## Morlais Project

# Metocean and Physical Processes Numerical Modelling Supplementary Note

Document Reference: PB5034-RHD-ZZ-XX-NT-Z-1006

Figure 3.1. Worst case scenario for effects on tidal currents

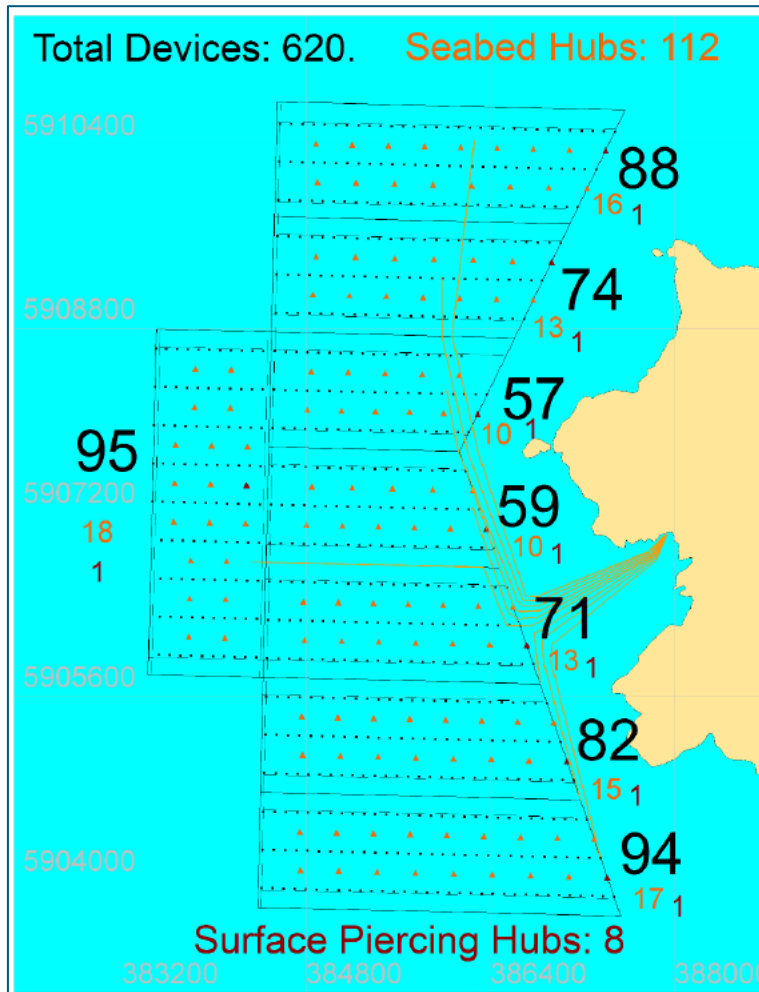
***Operational Impact 1: Changes to the Tidal Regime Due to Presence of Structures in the Project - NRW cannot agree with the magnitude of effect as there is still uncertainty within the assessment. It is unclear from Volume III how all the devices and associated infrastructure have been modelled and therefore the magnitude and temporal scale cannot be fully resolved. Scenario four considers 200 fewer turbines (408) compared to the worst-case scenario (620); whilst the energy rating may be the same, the infrastructure and spatial extent of change will be greater with >200 more turbines within the water column.***

The presence of the devices and their foundation or support structures has the potential to alter the baseline tidal regime, particularly tidal currents. Any changes in the tidal regime may have the potential to contribute to changes in seabed morphology due to alteration of sediment transport patterns. To investigate this issue, numerical modelling has been used to determine the changes in the baseline tidal regime arising from the worst-case scenario.

The modelled worst-case scenario comprises 620 sea-bed mounted devices, 112 electrical sea bed hubs, eight surface-piercing electrical hubs (each 6m diameter) and nine cable routes with rock bag protection. This is considered the worst-case scenario because it is the largest number of devices that could be used to achieve the maximum 240MW export capacity of the Project, and all the devices would have some form of interaction with the sea bed via their foundations or moorings. Sea-bed mounted devices would have the greatest blockage effect on tidal currents passing around them. The worst-case device configuration is described in Figure 3.1. Details of the method used to represent devices and structures in the flow model are provided in HR Wallingford (2020, Document Number DER6261-RT001-R01-00).

Figure 3.4. Worst case scenario for effects on waves

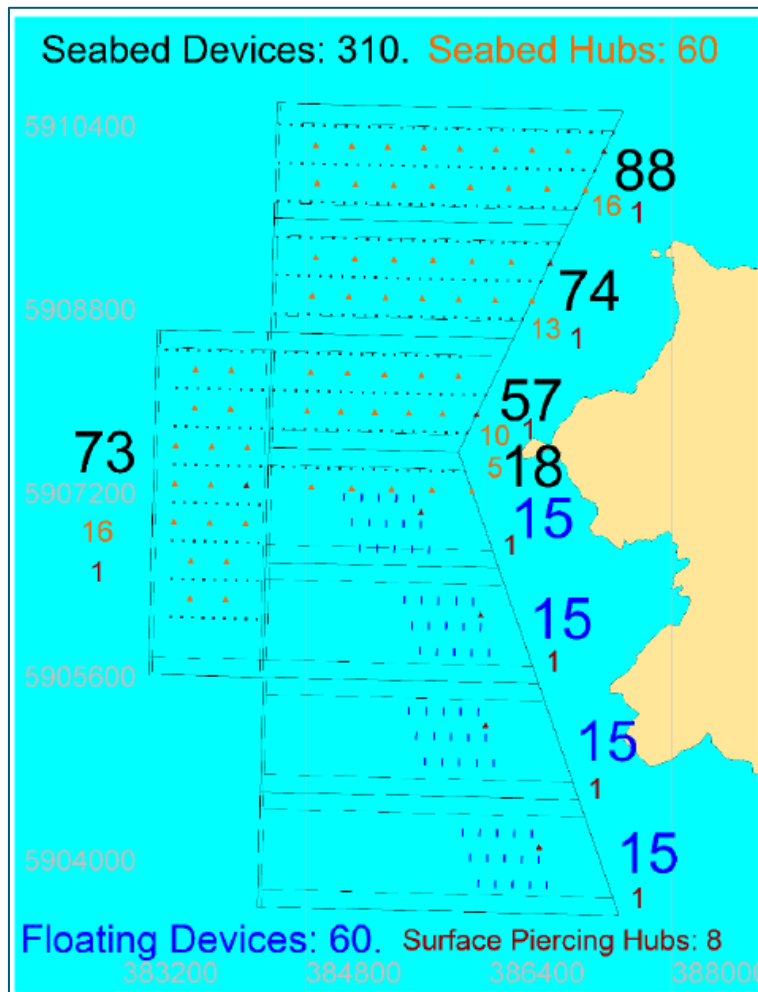
***Operational Impact 2: Changes to the Wave Regime Due to Presence of Structures in the Project - NRW cannot agree with the magnitude of effect as there is still uncertainty within the assessment. No wave data or modelling has been carried out for the site and only a desk-based study on wind farm devices as a proxy. NRW does not feel this is adequate given the scale of the project.***

Once installed within the array, tidal devices and their associated foundations or support structures will have the potential to affect the baseline wave regime. The changes could lead to a modification of the wave regime downstream of the array and could result in changes in sea bed morphology due to alteration of sediment transport patterns. To investigate this issue, numerical modelling has been used to determine the changes in the baseline wave heights arising from the worst-case scenario.

The modelled worst-case scenario for waves is different to that for tidal currents. It comprises 60 floating devices located in the southern part of the array (as they are not allowed to be located in the northern part), 310 sea-bed mounted devices, 60 sea bed hubs, and eight surface-piercing hubs. This configuration of devices would have the greatest effect on waves. Floating devices

would have a greater impact on waves than sea-bed mounted devices as they can directly block waves. As the sea-bed mounted structures are located in relatively deeper water (30-40m depth) the effect of these structures on waves would be lower. The worst-case device configuration is described in Figure 3.4. Details of the method used to represent devices and structures in the flow model are provided in HR Wallingford (2020, Document Number DER6261-RT001-R01-00).

Figure 3.7. Changes in yearly averaged residual sediment transport due to the Project (HR Wallingford, 2020, Document Number DER6261-RT001-R01-00)

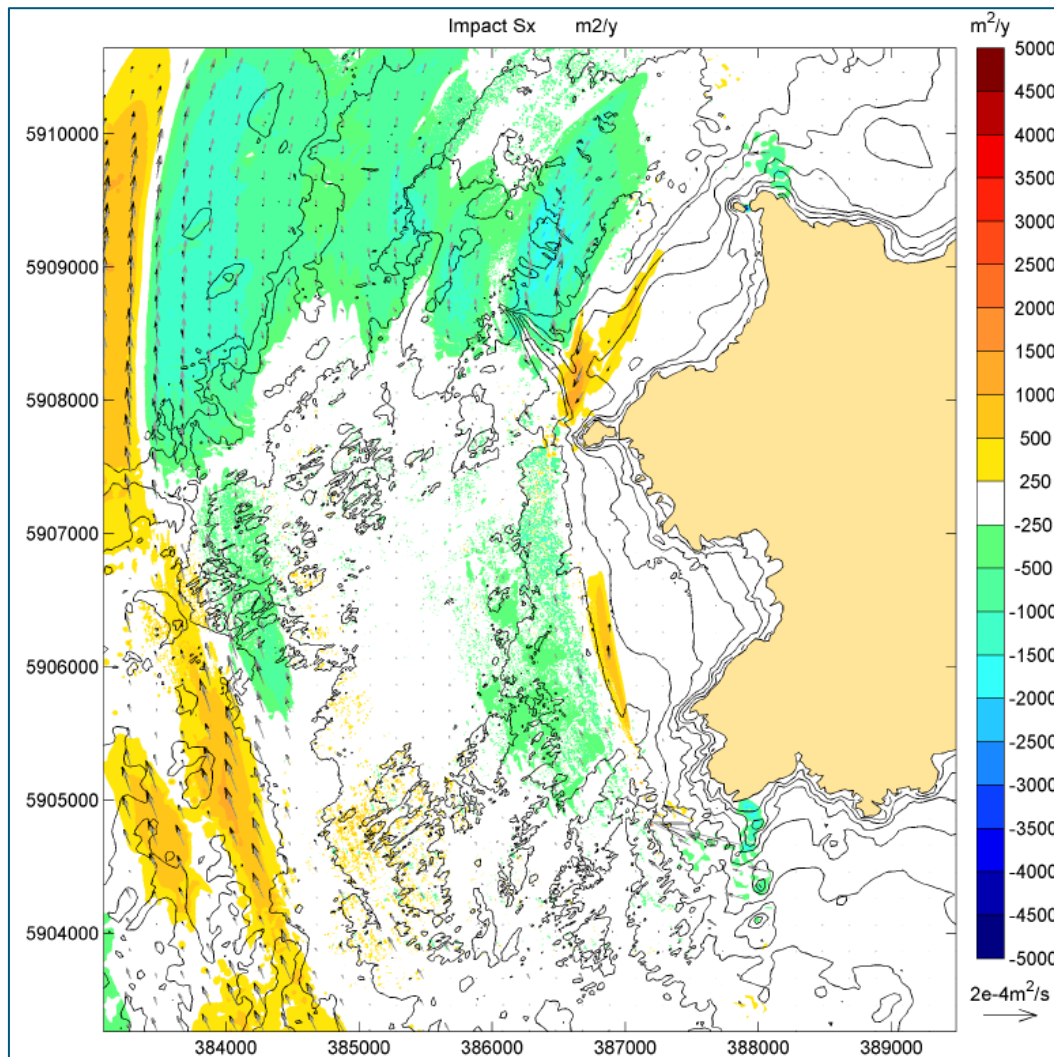
**Operational Impact 3: Changes to the Sediment Transport Regime Due to Presence of Structures in the Project - NRW cannot agree with the magnitude of effect as there is still uncertainty within the assessment. The worst-case scenario of device number and footprint varies throughout the document but would benefit from a standard approach. NRW would recommend consideration of work by Bangor University to understand tidal turbine impacts on morphodynamics such as: S.P. Neill, J.R. Jordan, S.J. Couch. Impact of tidal energy converter (TEC) arrays on the dynamics of headland sand bank. Renew Energy, 37 (1) (2012), pp. 387-397**

Figure 3.7 shows the changes in yearly averaged residual sediment transport due to the Project. Comparing these predictions with the baseline residual transport shows that they are less than 10-20% of the baseline residual transport. The drag of the devices, which would reduce the tidal current velocities in the array results in a predicted reduction in the sediment transport rates. Transport rates over the sand waves offshore from Gogarth Bay are predicted to be 10-20% lower with the devices in place. This means that the migration rates of the sand waves, which is currently about 30m/year (measured using bathymetry comparisons) would reduce by about 5m/year, which would be within the natural variation of the measured migration rates. Offshore from the array, the predicted flow velocities are higher, and the resulting residual transport rate is also predicted to be higher.

An increase in residual transport rate is also predicted to occur north of South Stack at the periphery of Gogarth Bay, and towards South Stack, but there is a predicted reduction in residual transport away from South Stack further offshore. This means that the circulation of sediment to and from South Stack sand bank would change; the residual transport away from the offshore tip

is predicted to reduce whilst the return residual transport to the nearshore part of the bank is predicted to increase. This could lead to a reconfiguration of the bank with the offshore tip potentially moving slightly north. However, the volume of sediment that is moving towards the bank (a gain of about 2,000m<sup>3</sup> per spring-neap cycle) is very small compared to the volume of the bank (850,000m<sup>3</sup>), and so the size of the bank is unlikely to change significantly in the long-term. This would also be within the natural variation of the position of the bank.
